Batemans Bay Bridge replacement

Review of environmental factors
consistency review 2 – temporary boat
ramp

Roads and Maritime Services | April 2019

Prepared by SLR Consulting on behalf of John Holland and Roads and Maritime Services

Figure 2.1 Location of proposed modification

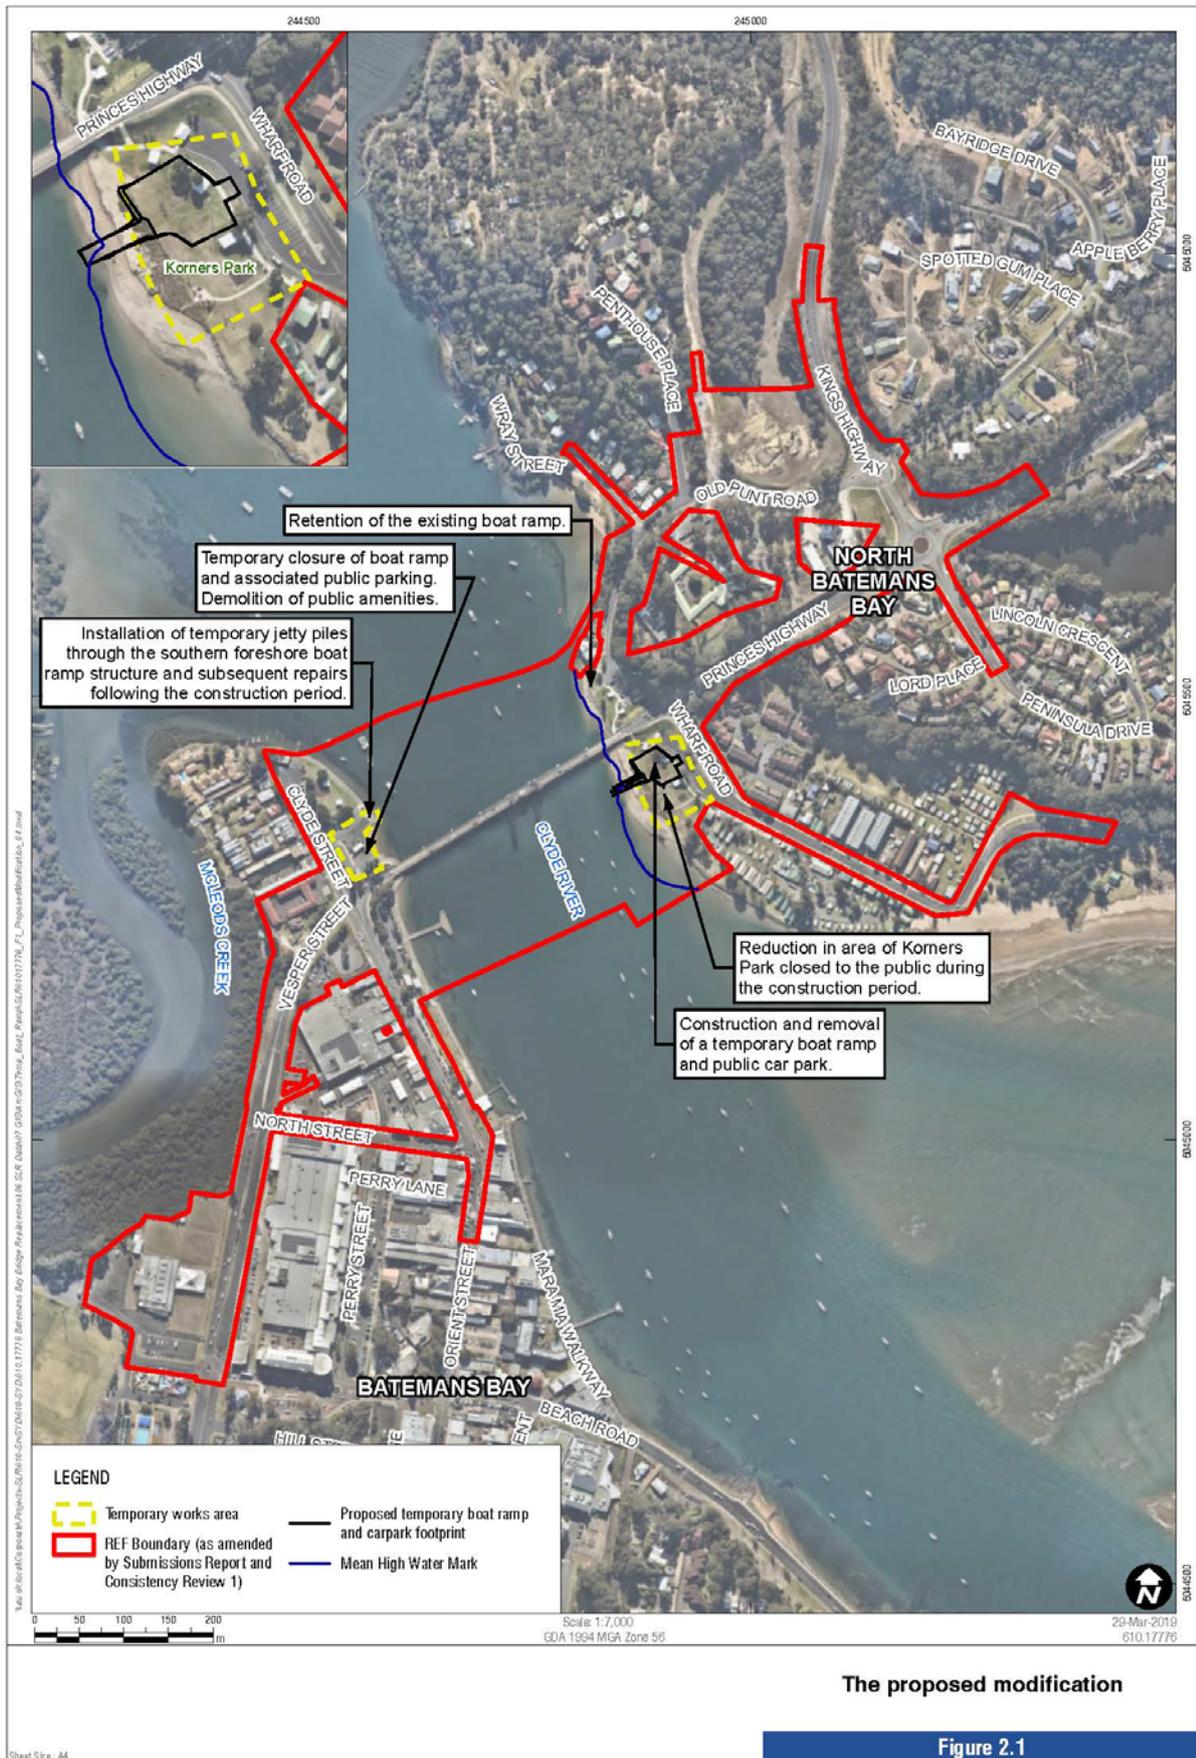
- the construction and removal of a temporary boat ramp and public car park at Korners Park on the northern foreshore of the Clyde River
- temporary closure of the southern foreshore boat ramp and associated public parking, demolition, then reinstatement of the public amenities off Clyde Street
- impact to the southern foreshore boat ramp structure due to installation of temporary jetty piles and subsequent repairs following the construction period
- retention of the existing boat ramp on the northern foreshore at the Old Punt Road car park during operation.

An overview of the proposed modification is shown in Figure 2.1. The proposed modification is described further in Section 2.1.1.
